87C196JQ SPECIFICATION UPDATE

Release Date: April, 1997
Order Number: 272857-003

The 87C196JQ may contain design defects or errors known as errata. Characterized errata that may cause the 87C196JQ's behavior to deviate from published specifications are documented in this specification update.

- Check for pending EPAX interrupts before exiting an EPAX ISR

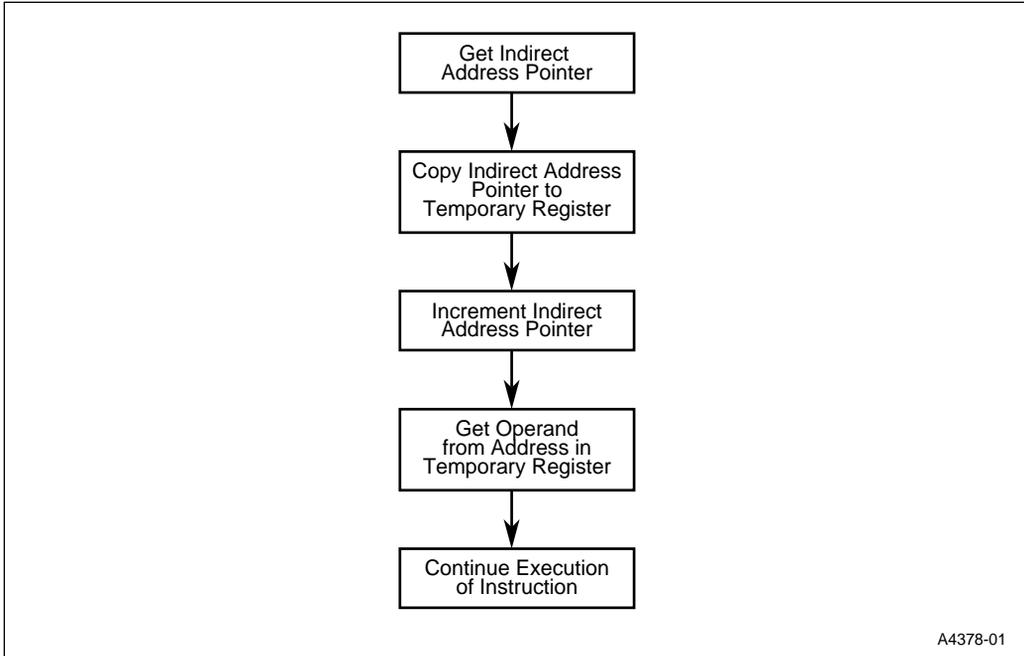
PROBLEM: The EPA can lock up if overruns are handled incorrectly. Overruns occur when an EPA input transitions at a rate that cannot be handled by the EPA interrupt service routine. If no overrun handling strategy is in place, and if the following three conditions exist, a situation may occur where both the capture buffer and the EPAX_TIME register contain data, and no EPA interrupt pending bit is set:

- an input signal with a frequency high enough to cause overruns is present on an enabled EPA pin, and
- the overwrite bit is set (EPAX_CON.0 = 1; old data is overwritten on overrun), and
- the EPAX_TIME register is read at the exact instant that the EPA recognizes the captured edge as valid.

The input frequency at which this occurs depends on the length of the interrupt service routine as well as other factors. Unless the interrupt service routine includes a check for overruns, this situation will remain the same until the device is reset or the EPAX_TIME register is read. The act of reading EPAX_TIME allows the buffered time value to be moved into EPAX_TIME. This clears the buffer and allows another event to be captured. Remember that the act of transferring the buffer contents to the EPAX_TIME register is what actually sets the EPAX interrupt pending bit and generates the interrupt.

Another method for avoiding this situation is to check for pending EPA interrupts before exiting the EPA interrupt service routine. This is an easy way to detect overruns and additional interrupts. It can also save loop time by eliminating the latency necessary to service the pending interrupt. However, this method cannot be used with the peripheral transaction server (PTS).

Figure 1. 16-bit System with EPROM

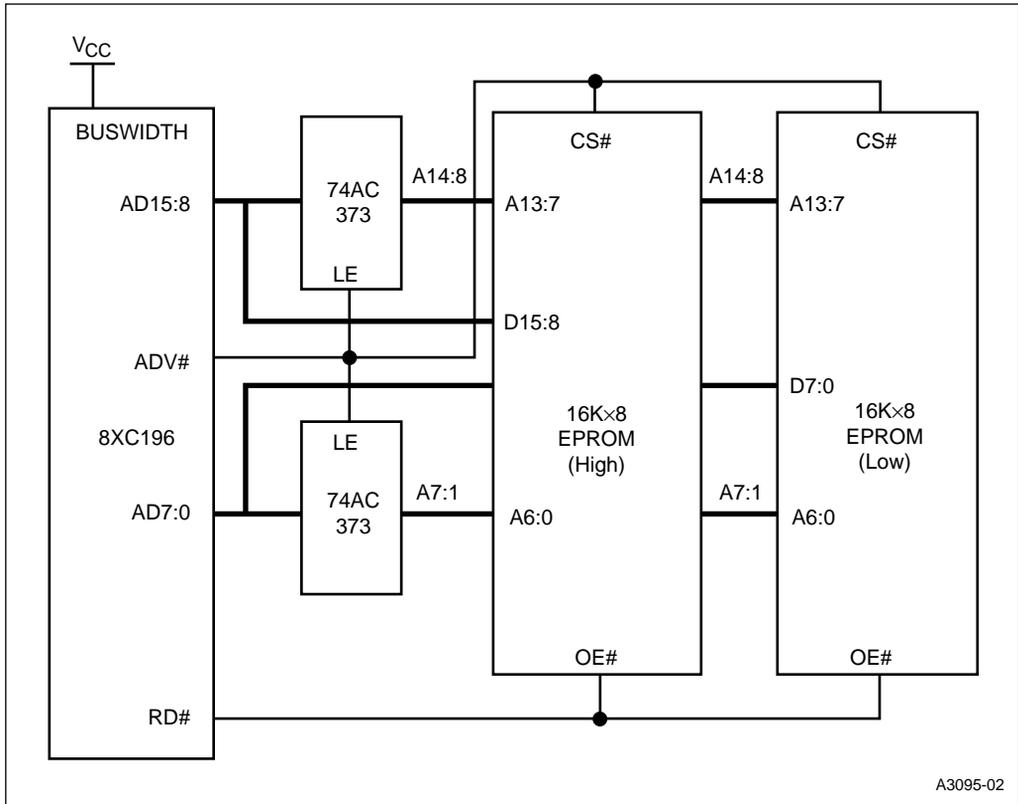
001. *High address inputs to the low EPROM should be A14:8 in Figure 15-18.*

ITEM: The next revision of the user's manual will include the following corrected graphic.
